PRAIRIE ISLAND NUCLEAR GENERATING PLANT UNIT NO. 1

AMENDMENT TO FACILITY OPERATING LICENSE

Amendment No. 35
License No. DPR-42

SAFETY EVALUATION BY THE OFFICE OF NUCLEAR REACTOR REGULATION
SUPPORTING AMENDMENT NO. 35 TO FACILITY OPERATING LICENSE NO. DPR-42
AMENDMENT NO. 29 TO FACILITY OPERATING LICENSE NO. DPR-60
NORTHERN STATES POWER COMPANY
PRAIRIE ISLAND NUCLEAR GENERATING PLANT UNIT NOS. 1 and 2
DOCKET NOS. 50-282 AND 50-306

HOT CHANNEL FACTOR NORMALIZED

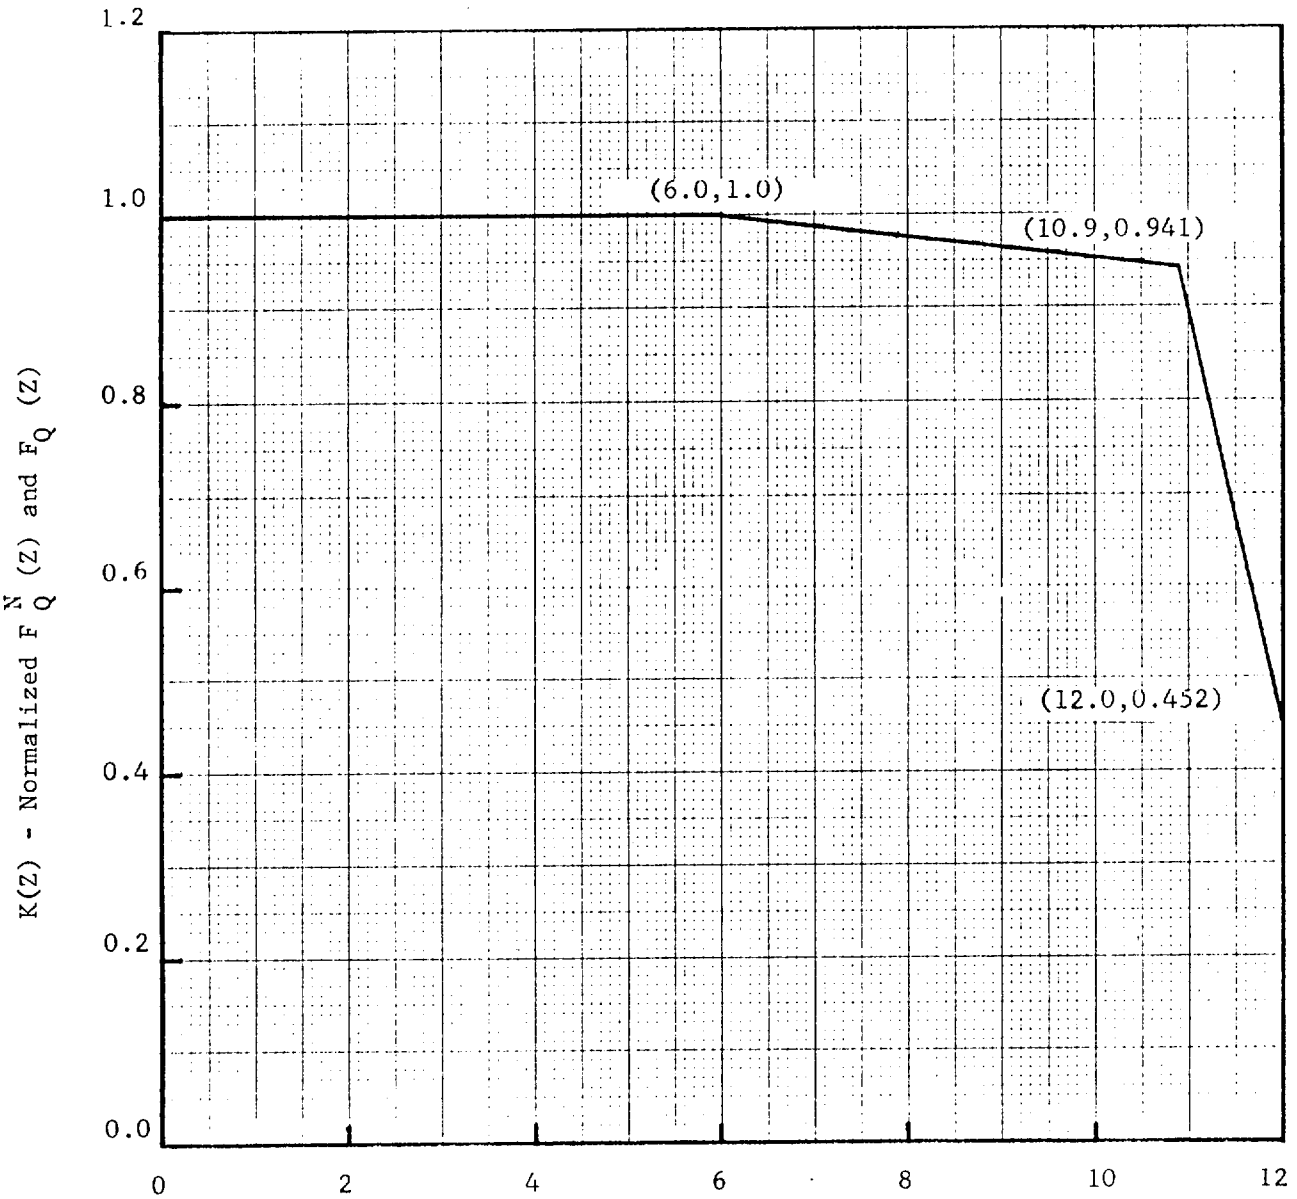
An upper bound envelope for $F_Q^N$ of 2.145 times the normalized peaking factor axial dependence of Figure TS.3.10-5 has been determined from extensive analyses considering all operating maneuvers consistent with the technical specifications on power distribution control as given in Section 3.10. The results of the loss of coolant accident analyses based on this upper bound envelope indicate an adequate peak clad temperature margin to the 2200°F limit.

(5) Change of the limiting value for the nuclear hot channel factor $F_Q^N$ from 2.25 to 2.145 and modification of the hot channel factor normalized operating envelope (Fig. TS 3.10-5)

Figure TS.3.10-6 DEVIATION FROM TARGET FLUX DIFFERENCE AS A FUNCTION OF THERMAL POWER

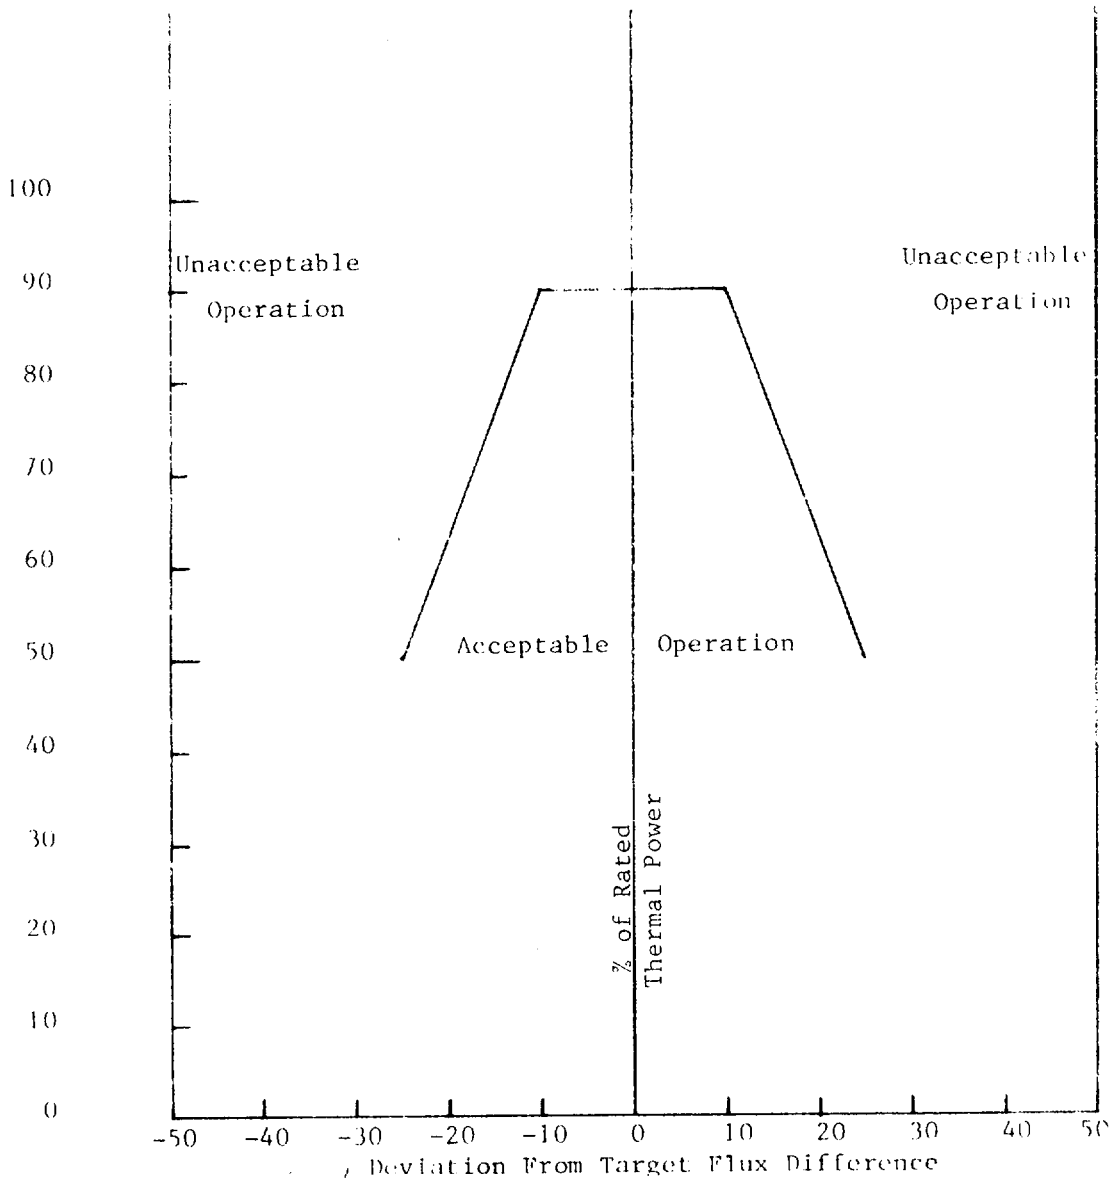
a. The indicated axial flux difference may deviate from its $\pm$ 5% target band for a maximum of one* hour (cumulative) in any 24-hour period provided that the difference between the indicated axial flux difference and the target flux difference does not exceed an envelope bounded by -10 percent and +10 percent at 90% power and increasing linearly to -25 percent and +25 percent at 50 percent power as shown in Figure TS.3.10-6.

(1) Change of the limit curve for target flux difference (Fig. TS 3.10-6)

V(Z) as a Function of Core Height

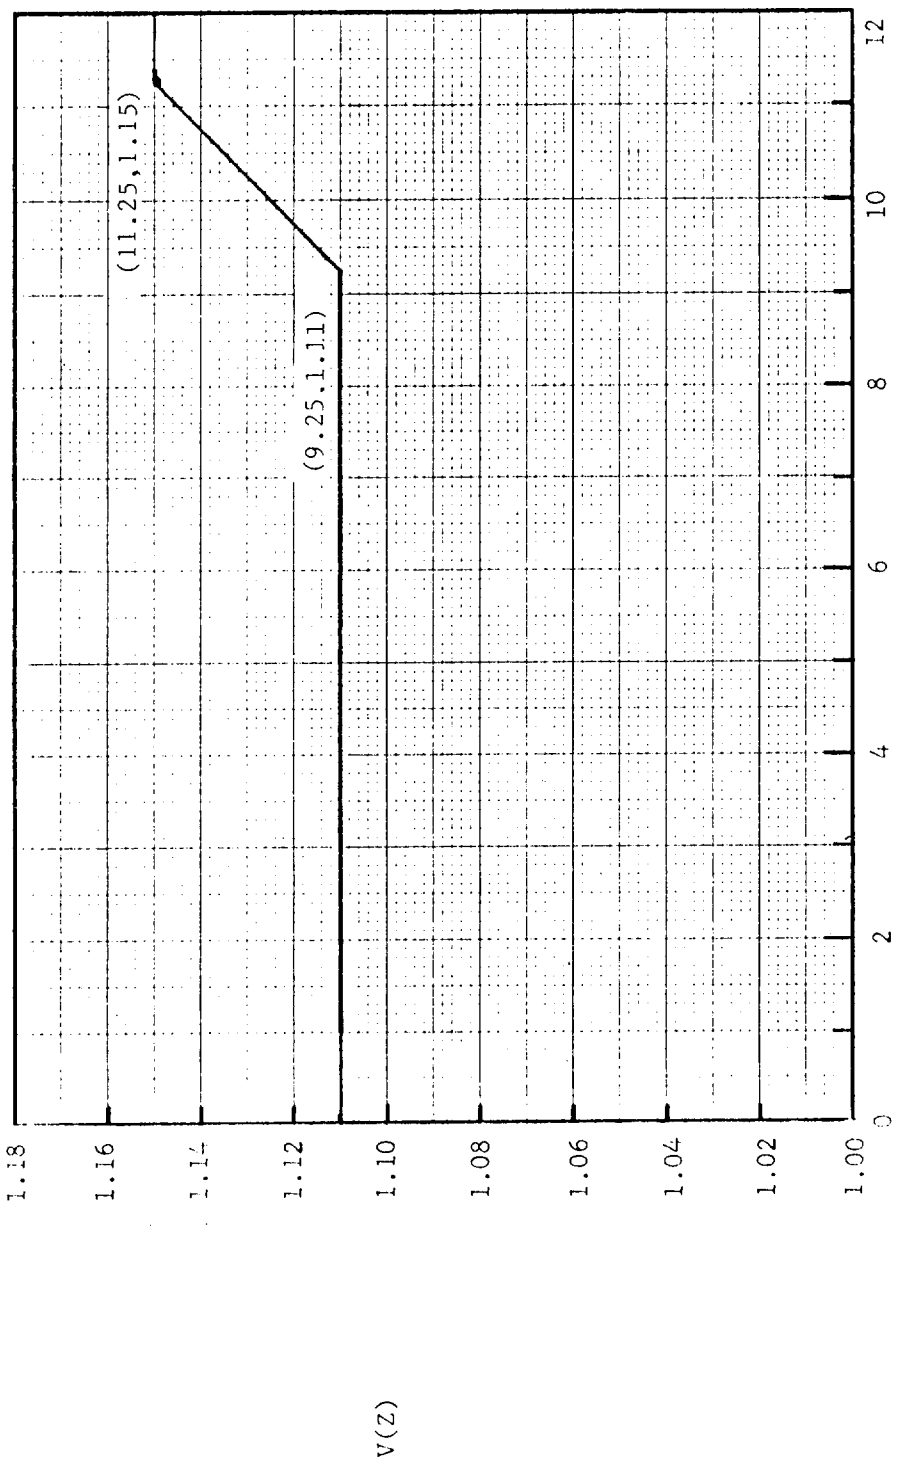
(6) V(Z) is the function given in Figure TS.3.10-8
(7) $P^1$ is the largest fraction of full power at which the plant will operate prior to the next target flux measurement.
